# MERIDIAN STORAGE

**CONSTRUCTION DRAWINGS**

REVISED ALL PROJECT **DOCUMENTS TO CORRECT** FILING NUMBER

VR239 & SDP2336

10/20/2023 SITE PLAN

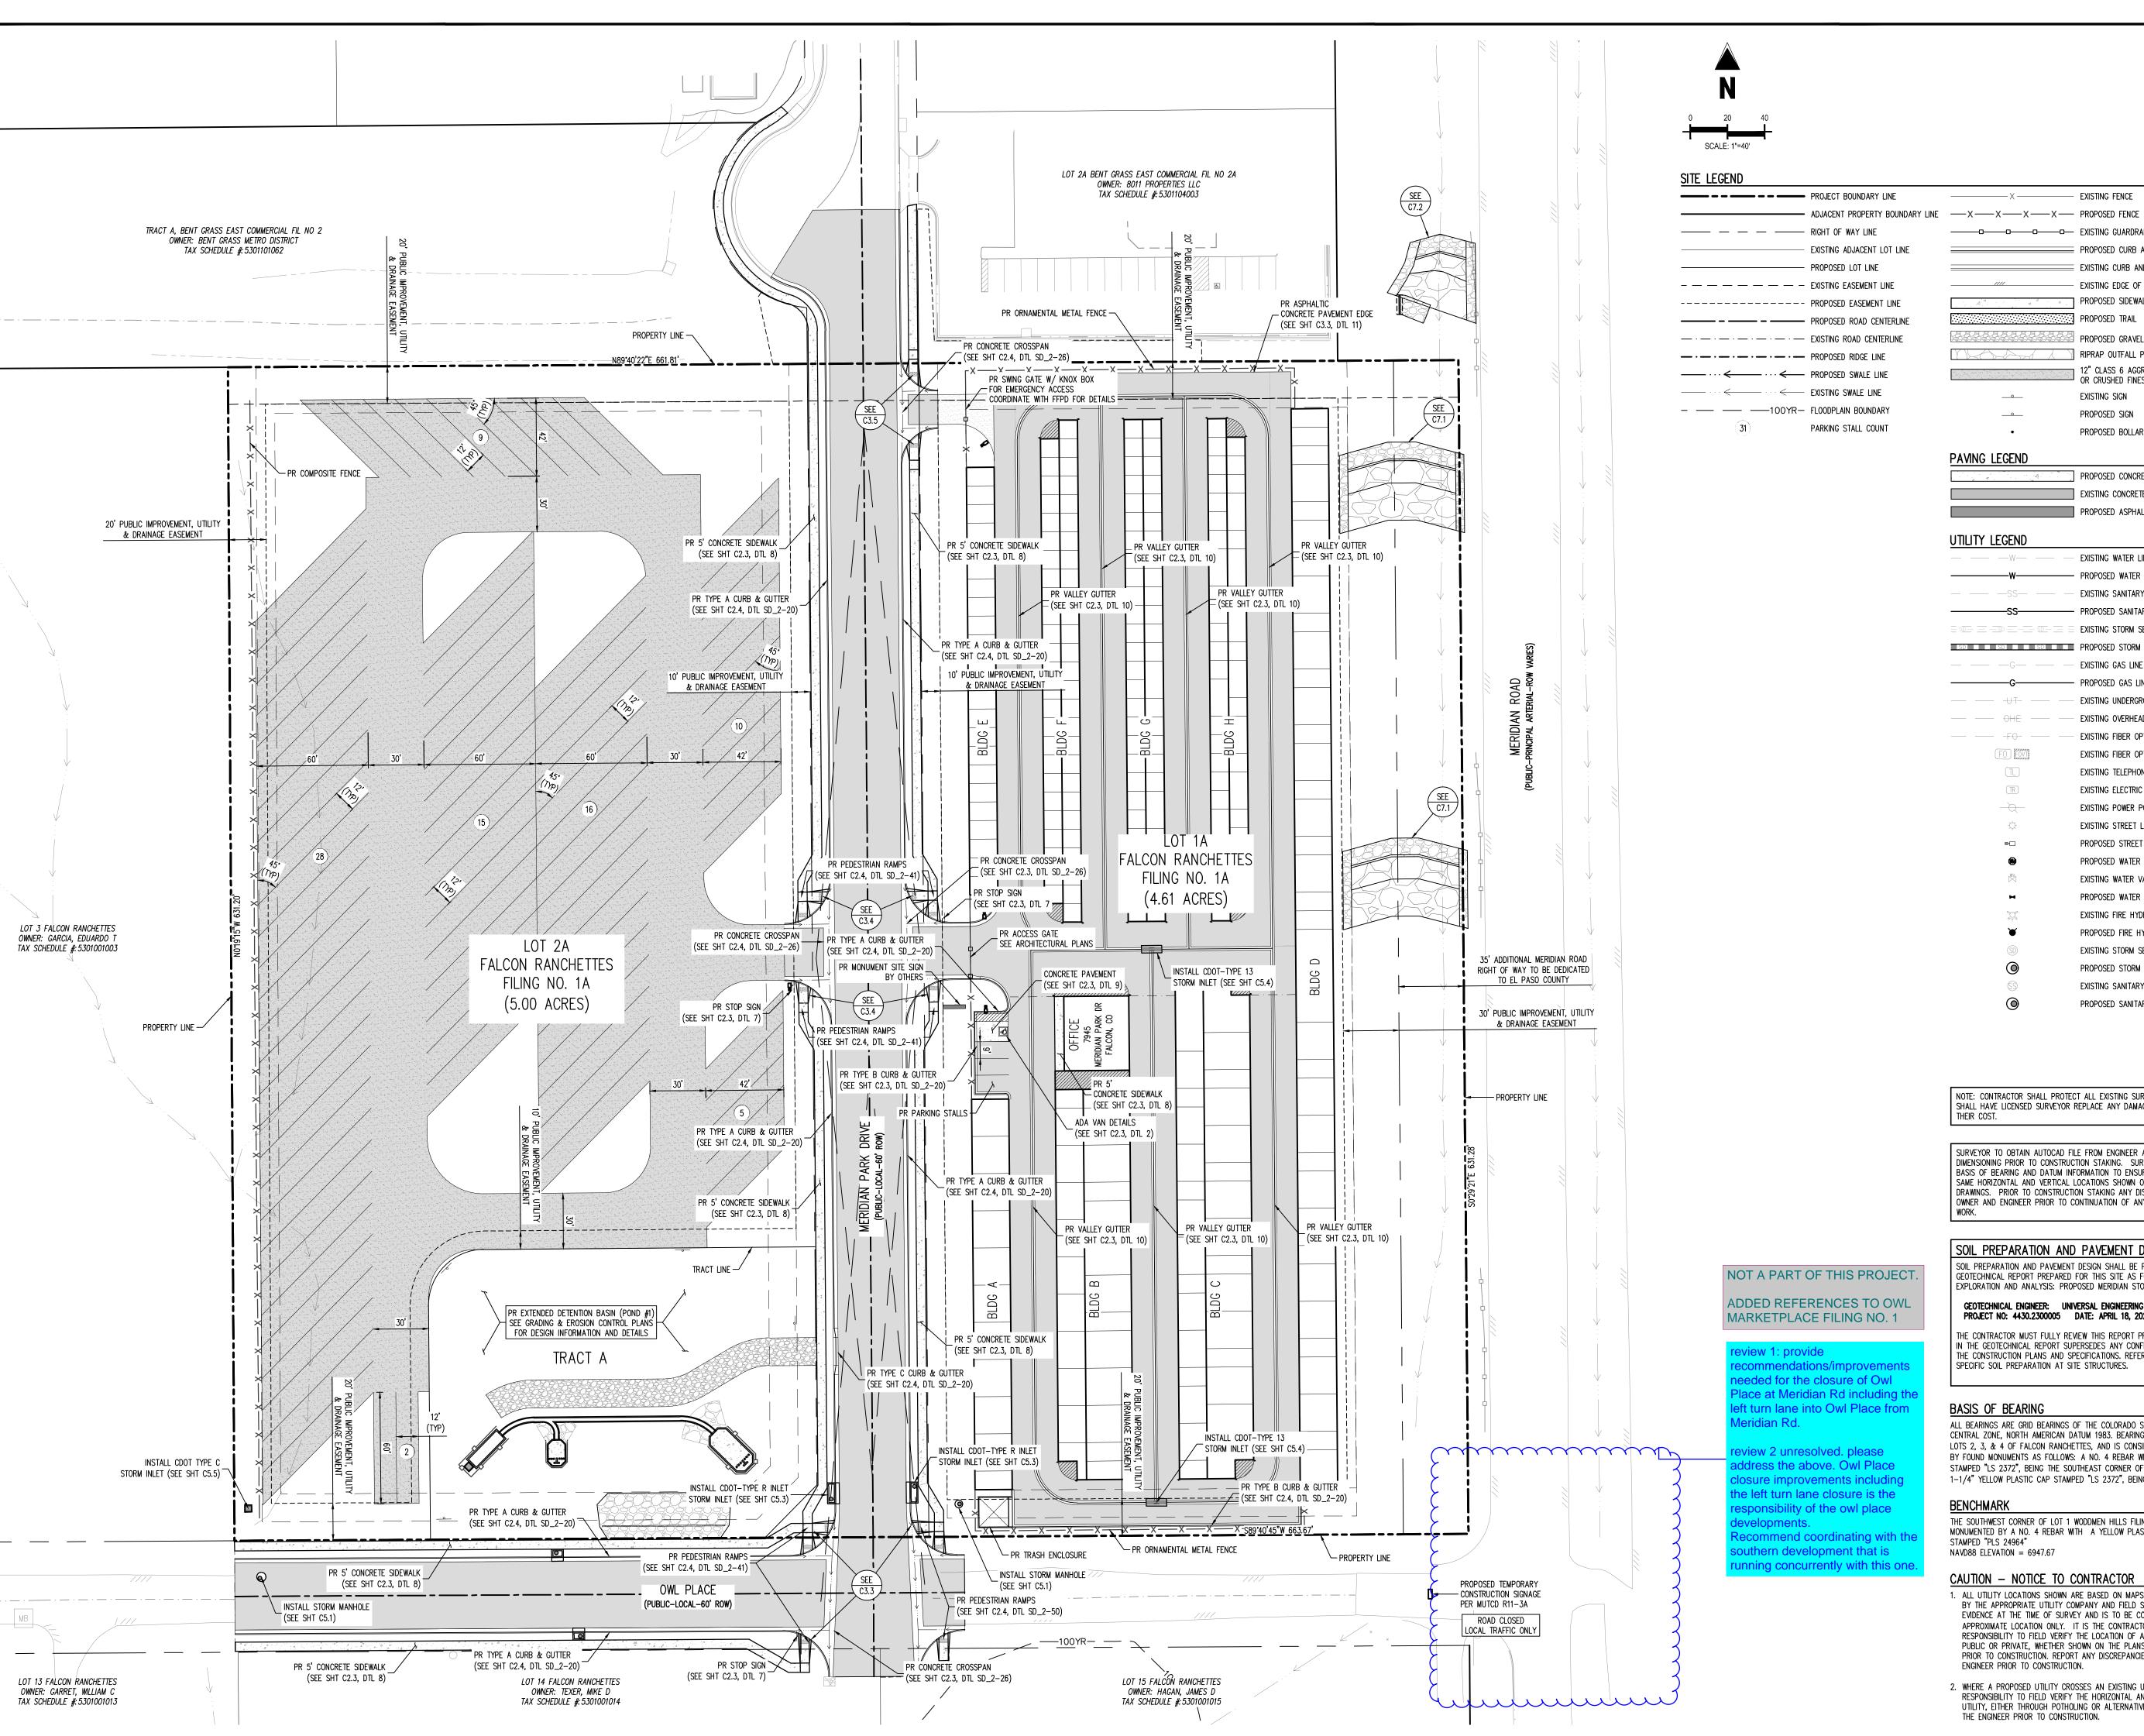
NOT A PART OF THIS PROJECT ADDED REFERENCES TO OWL

ADDED REFERENCES TO OWL MARKETPLACE FILING NO. 1

REVISED LINEWORK TO SHOW UP-TO-DATE IMPROVEMENTS

INTERSECTION DETAILS

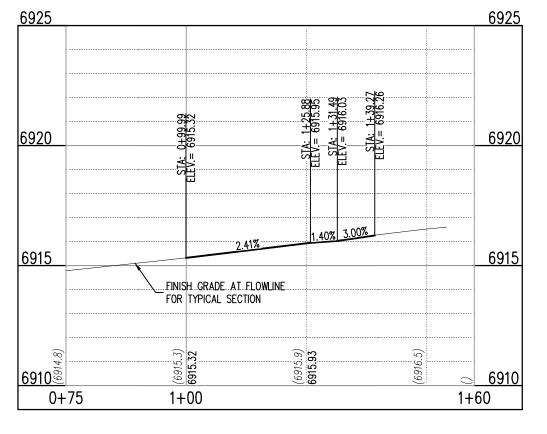
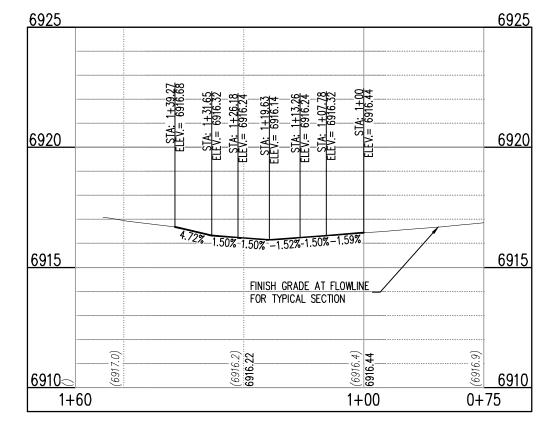
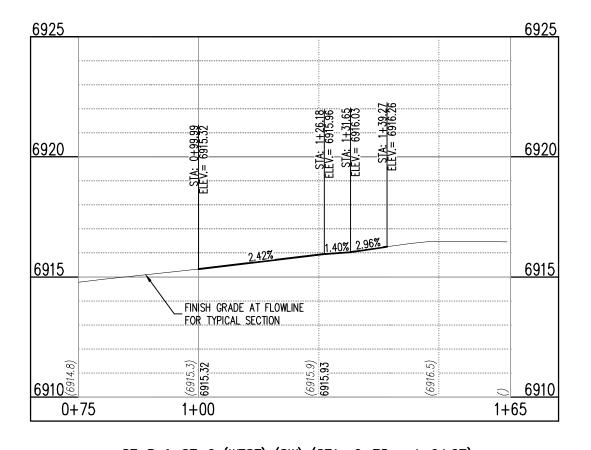
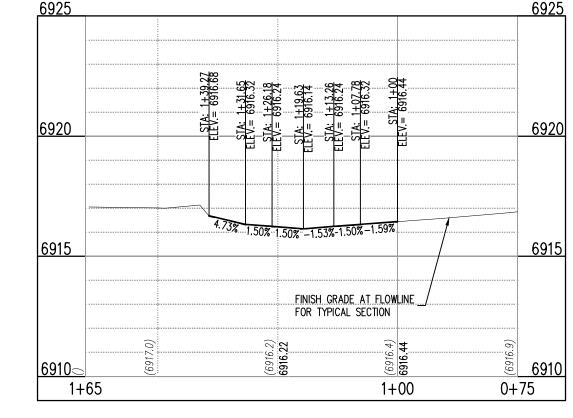
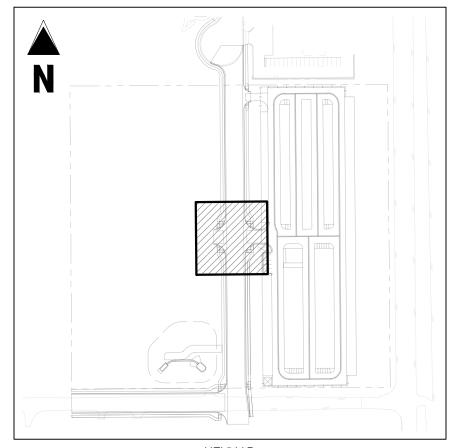
REVISED GRADING TO CONFORM WITH ADA STNADARDS
